**RE: S4.56 MODIFICATION APPLICATION – DA2018/1654 AT 181 FOREST WAY, BELROSE**

This Statement of Environmental Effects (SEE) has been prepared by Mecone Group Pty Limited (**Mecone**) on behalf of Regis Aged Care Pty Ltd (**Regis**) to support a Section 4.56 Modification Application (**DA**) to Northern Beaches Council (**Council**) for changes to development consent DA2018/1654 at 181 Forest Way, Belrose (the **site**).

*Amendments to ground level parking, rationalization of floorplans and layouts, design refinements to outdoor recreation areas, creation of new sub-terrace generator room, installation of rooftop PV panels and administrative amendments to conditions of consent*

**Figure 3.** Proposed Plans – Entry Courtyard  
 Source: Morrison Design Partnership Pty Ltd

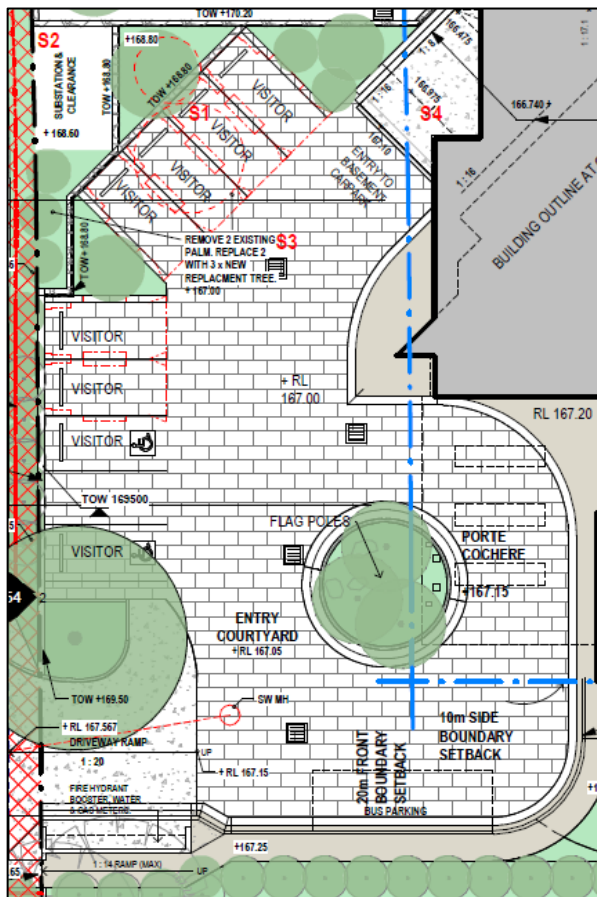
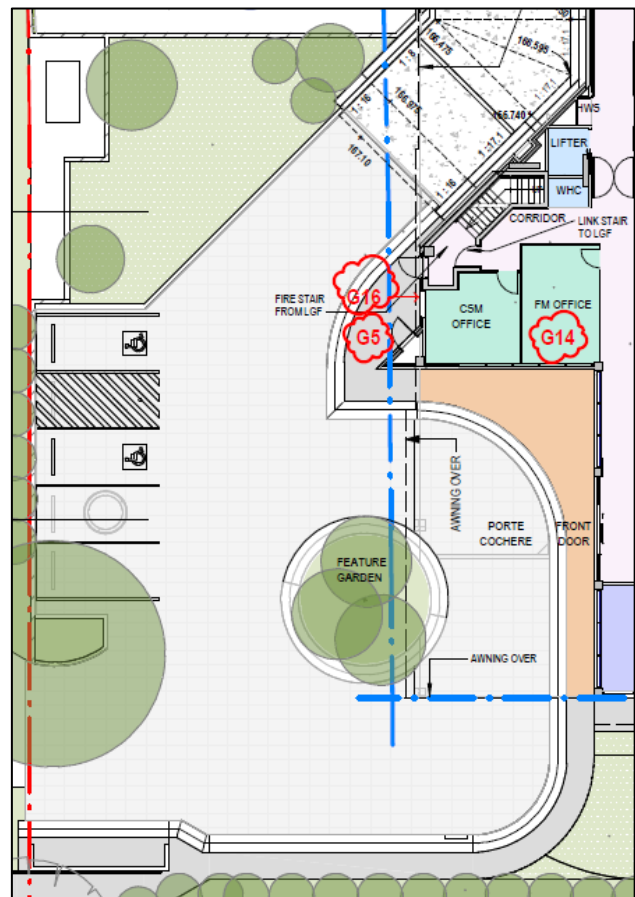
As indicated in **Figure 3** below, the proposal will remove four visitor car parking spaces adjacent to the eastern side of the ramp to the basement. This amendment to the ground level parking is a direct response to Condition 11A of the determination made on 28 April 2023. Condition 11A states:

*The four car spaces (and the aprons which adjoin these car spaces) shown adjacent to the eastern side of the ramp to the basement are to be deleted from the plans (including but not limited to architectural, landscape and stormwater).*

**Figure 5. Proposed Plans – Emergency Vehicle Access**  
 Source: Morrison Design Partnership Pty Ltd

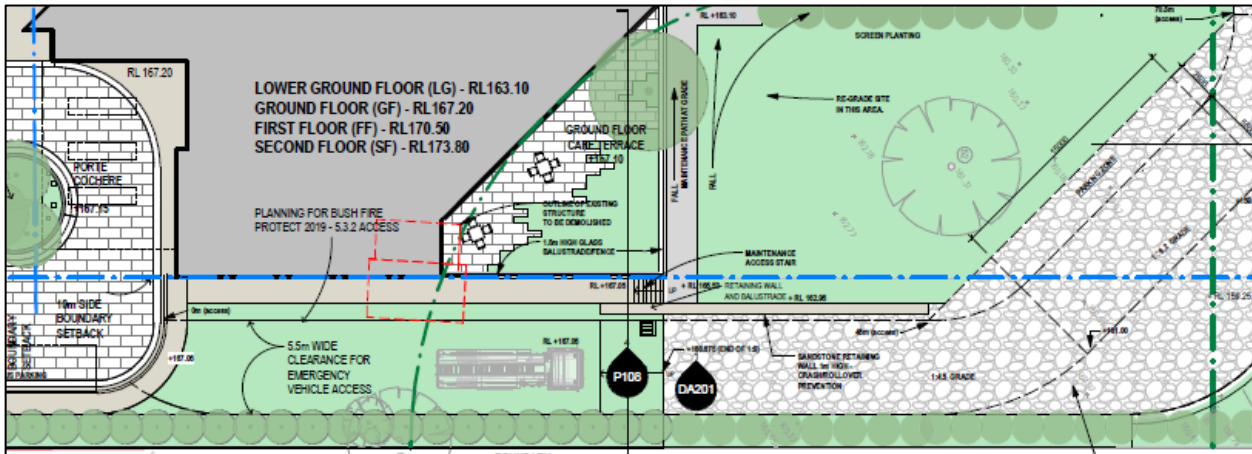
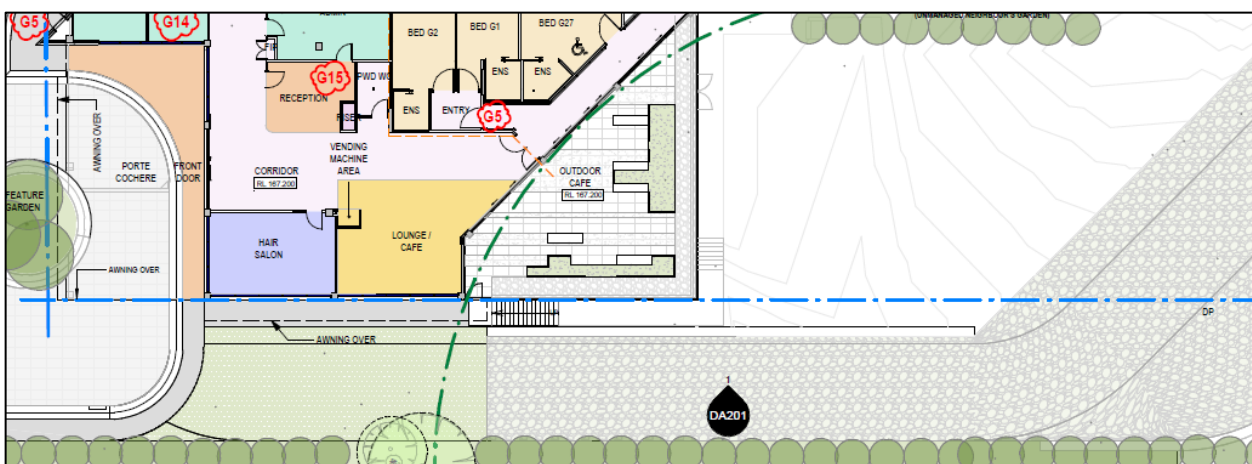
It is proposed that the emergency vehicular access to the south of the site will have an extended area of reinforced turf road surface further west into the clear emergency access point. As seen in **Figure 5**, this is a minor amendment to ensure ease of access for emergency vehicles.

**Figure 10.** Proposed Plans – Roof Plan – Amendments Highlighted  
Source: Morrison Design Partnership Pty Ltd (Amended by Mecone)

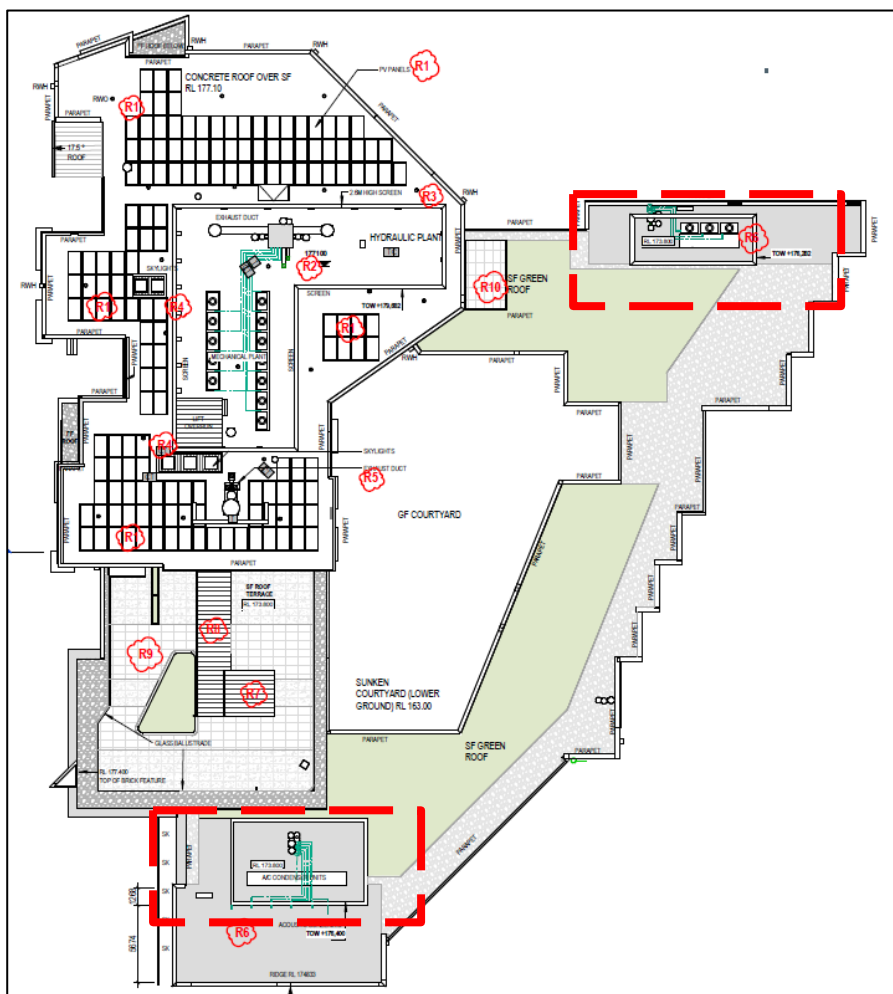
It is proposed for the approved acoustic screening on the rooftop is proposed to be extended by 0.98m alongside the installation of further acoustic screening on the second floor rooftops as shown in **Figure 11**. This adjustment in height and installation of acoustic screening is to better protect the acoustic amenity of neighbouring residents and to comply with the requirements of mechanical noise emissions - refer to **Appendix 6**. The height increase is necessary for the intended efficient operations of the approved scheme without causing decreased acoustic amenity for the residents and surrounding sites.

This modification seeks an increased the area of enclosure to mechanical and hydraulic plant area on the rooftop (refer to **Figure 11**) in response to the spatial requirements for the efficient operation and maintenance of the proposed plant.

Alongside the expanded rooftop plant area, it is proposed that rooftop photovoltaic panels (PV panels) are to be installed, these will sit below the maximum height of roof plant screening. Refer to **Figure 11**

**Figure 12. Proposed Plans – Lower Ground Floor**

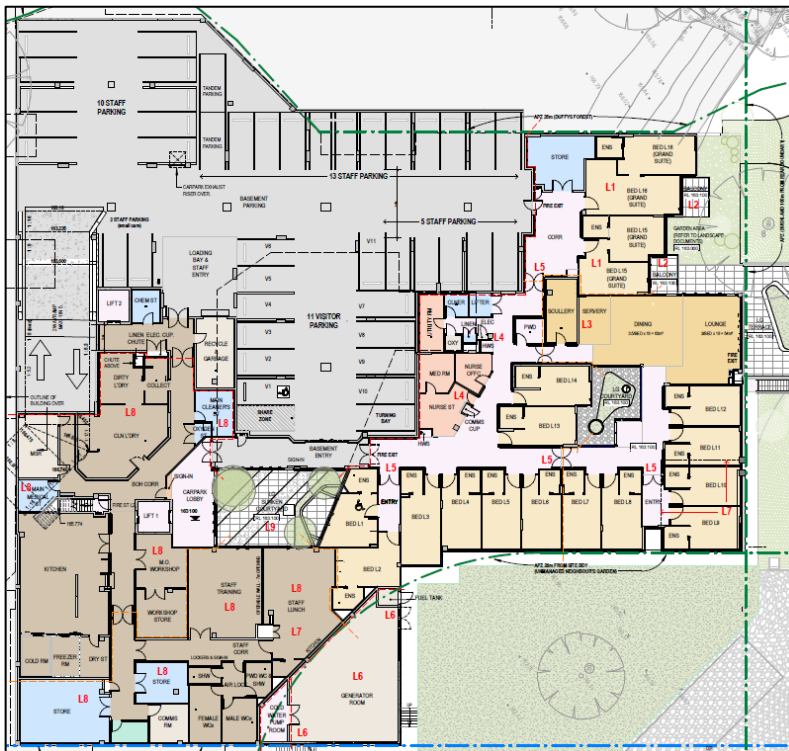
- Removal of 2x bedrooms, by amalgamating two bedrooms in north-eastern corner,
- Inclusion of 2x private balcony for north-eastern corner bedrooms,
- Redesign of courtyard, large terrace and sunken courtyard,
- Addition of generator room, main medical storage room, main cleaners’ storage room; and
- Addition of a cold room, freezer room and dry storage room.

**Figure 14. Proposed Plans – Ground Floor**  
 Source: Morrison Design Partnership Pty Ltd

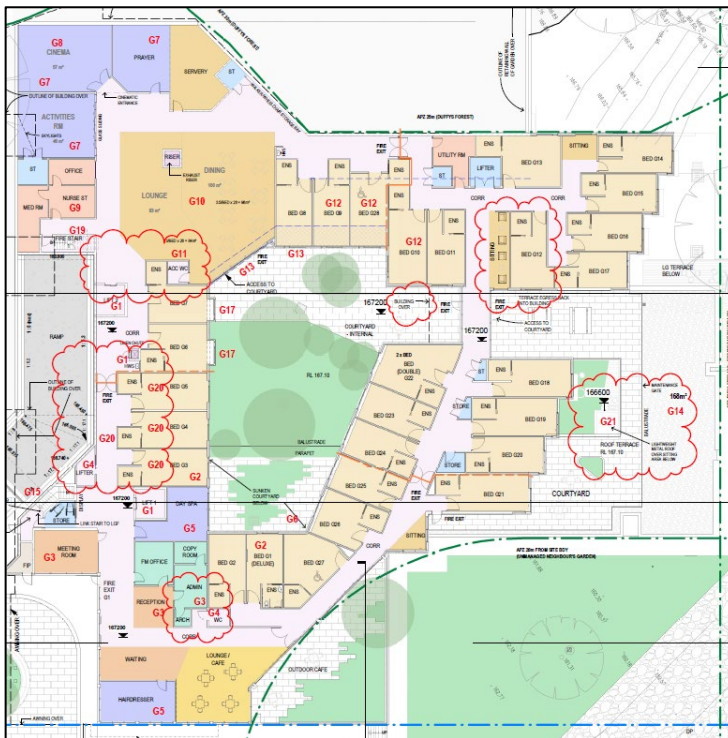
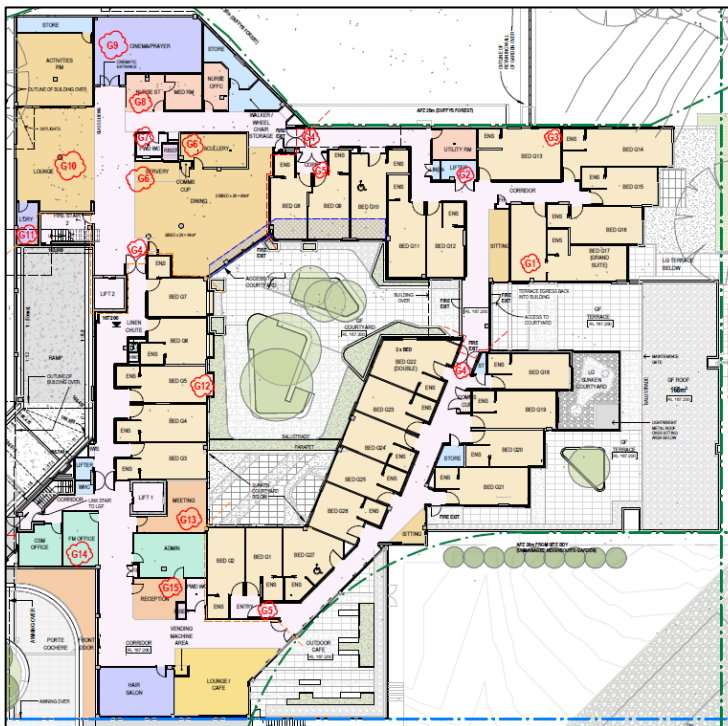
- Redesign of prayer and cinema rooms, admin office spaces, meeting rooms, and dining area,
- Reduction of 1x bedroom by amalgamation of bedrooms in north-eastern corner; and

- Redesign of courtyard and outdoor café.

**Figure 16. Proposed Plans – First Floor**  
 Source: Morrison Design Partnership Pty Ltd

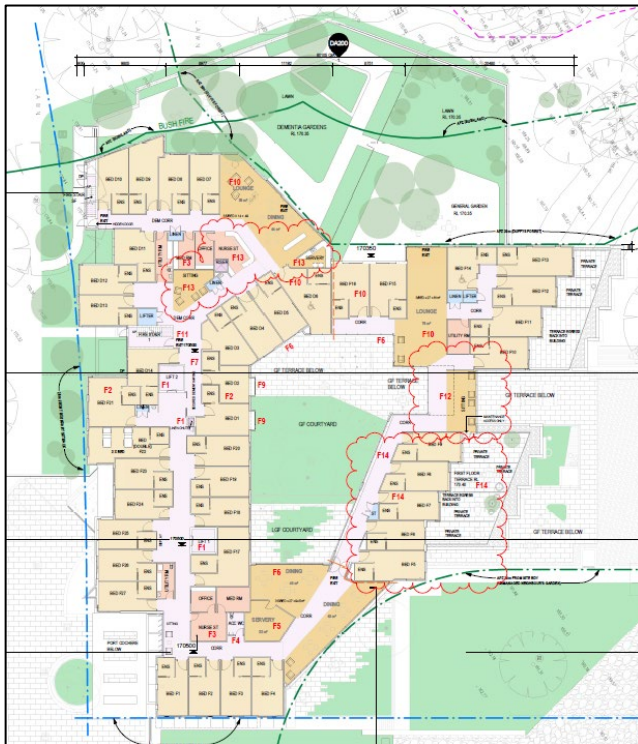
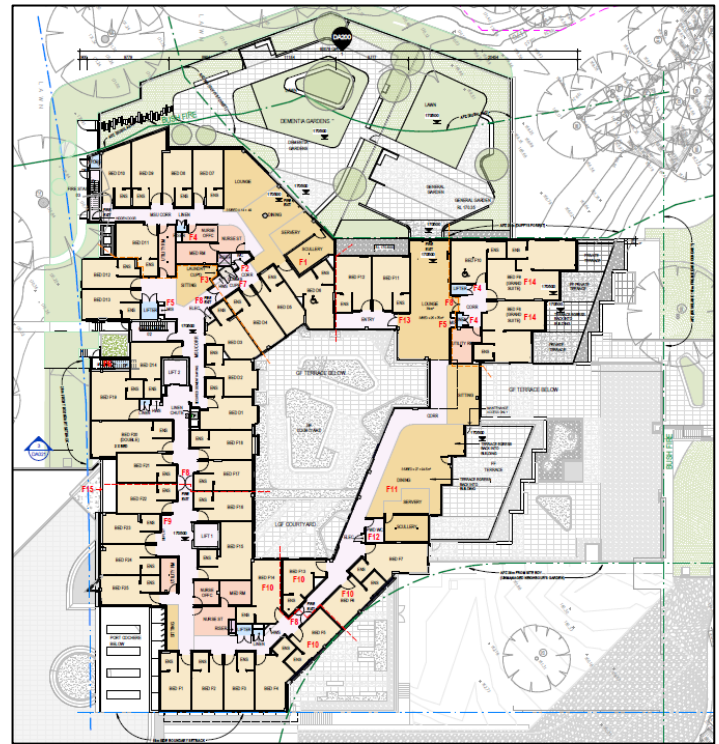
- Relocation of dining/servery area to have direct access to east facing terrace,
- Reduction of 2x bedrooms, by amalgamating two bedrooms in northeastern corner; and
- Inclusion of 2x private balcony for northeastern corner bedrooms.

**Figure 18. Proposed Plans – Second Floor**  
Source: Morrison Design Partnership Pty Ltd

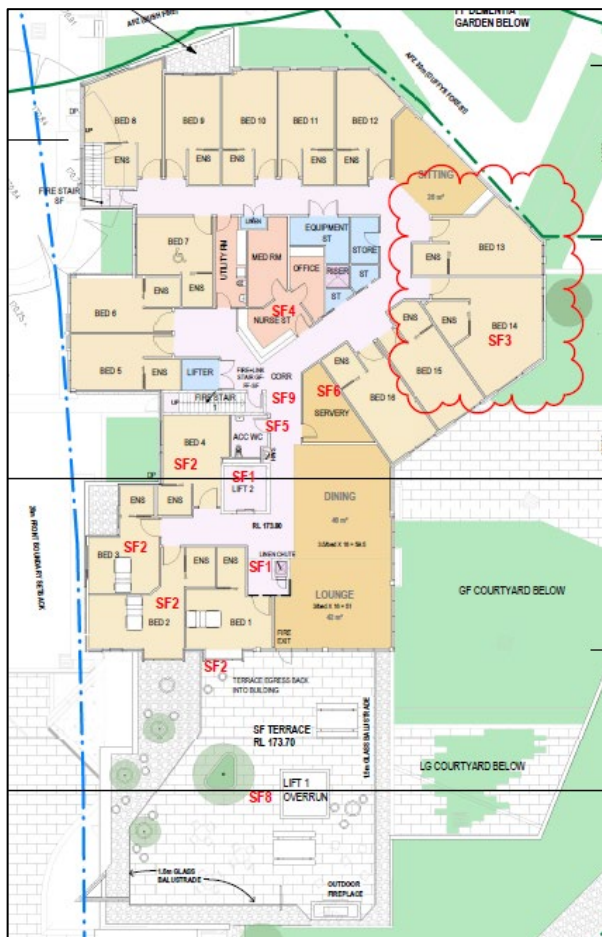
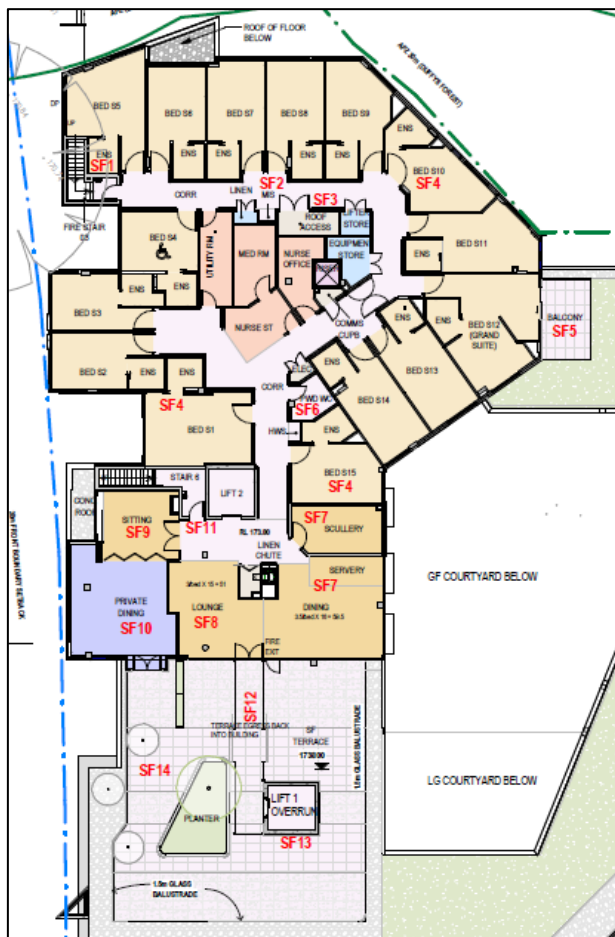
- Relocation and redesign of dining, sitting space, including new private dining space,
- Inclusion of 1x private balcony for eastern bedroom,
- Redesign of terrace space; and
- Loss of 1x bedroom due to redesign of dining, sitting spaces.

**Figure 22.** Proposed layout to OSD and WSUD Stormwater Management Layout  
 Source: ENTEC Consultants Pty Ltd

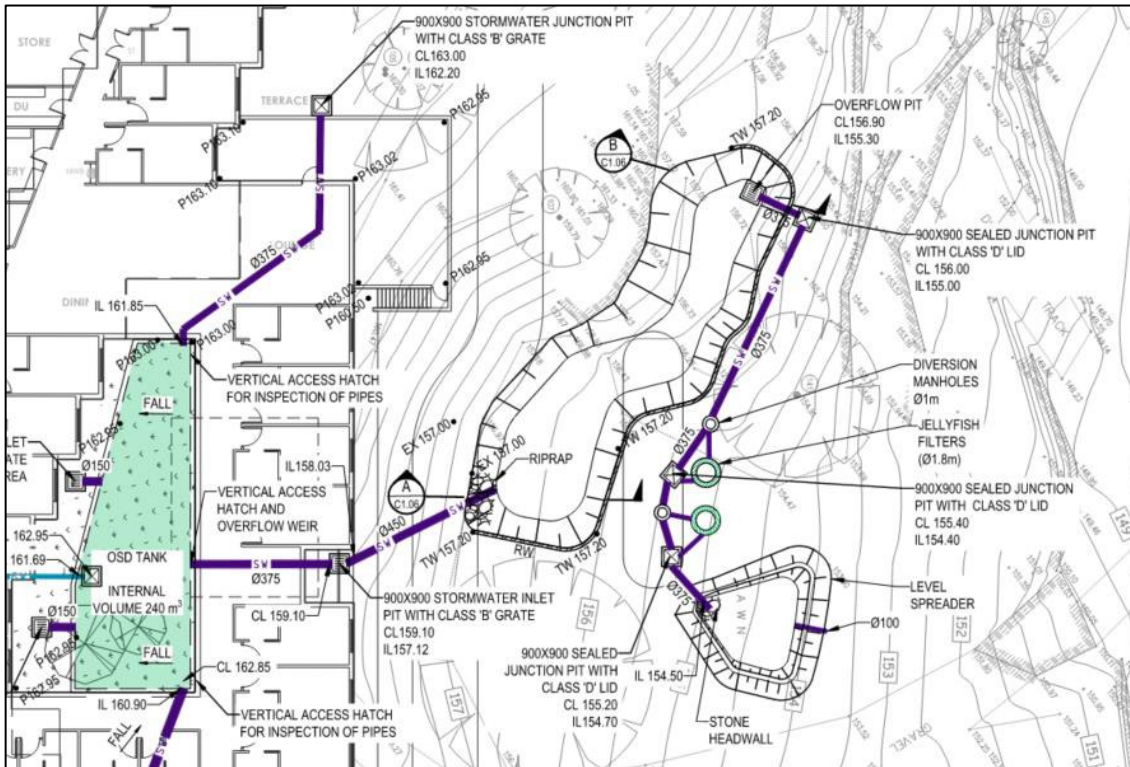
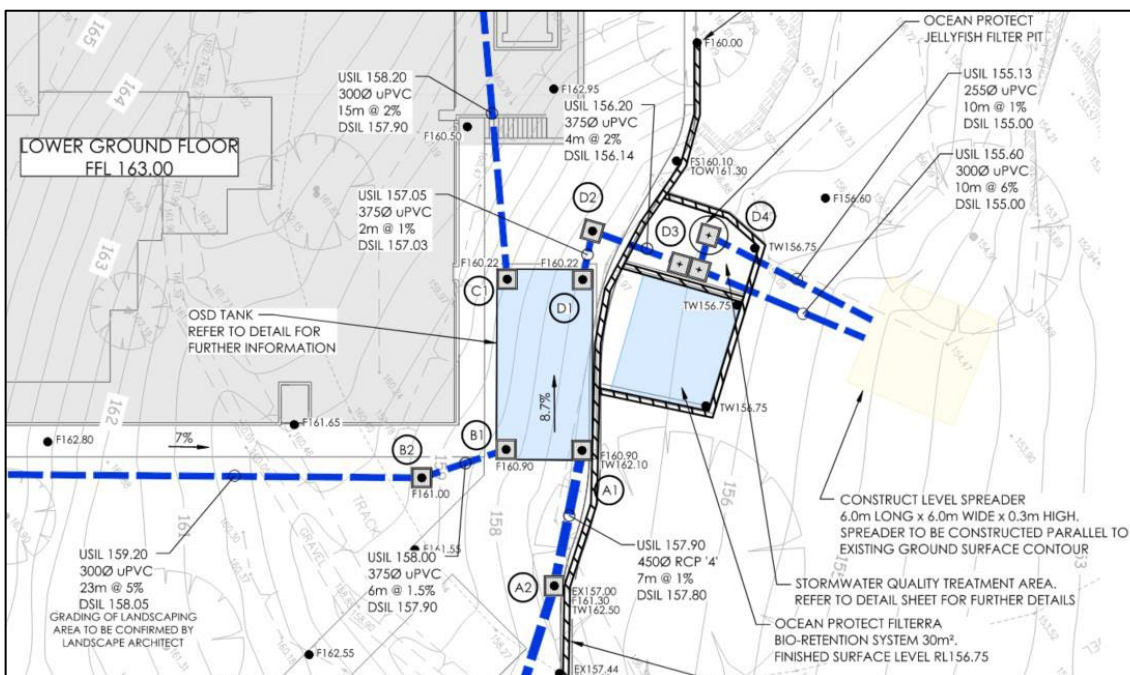
The proposal includes minor amendments to the civil stormwater management plan, including the relocation of the OSD from the building’s internal courtyard to outside the building’s footprint as indicated in **Figure 22** and **Figure 23**, as well as the amendments and the substitution of the WSUD stormwater quality treatment devices. As stated in the Civil Stormwater Amendment Letter (refer to **Appendix 10**), the amendments do not alter the intent of the approved site stormwater management strategy and will still meet Council’s requirements as expressed in Condition 16.
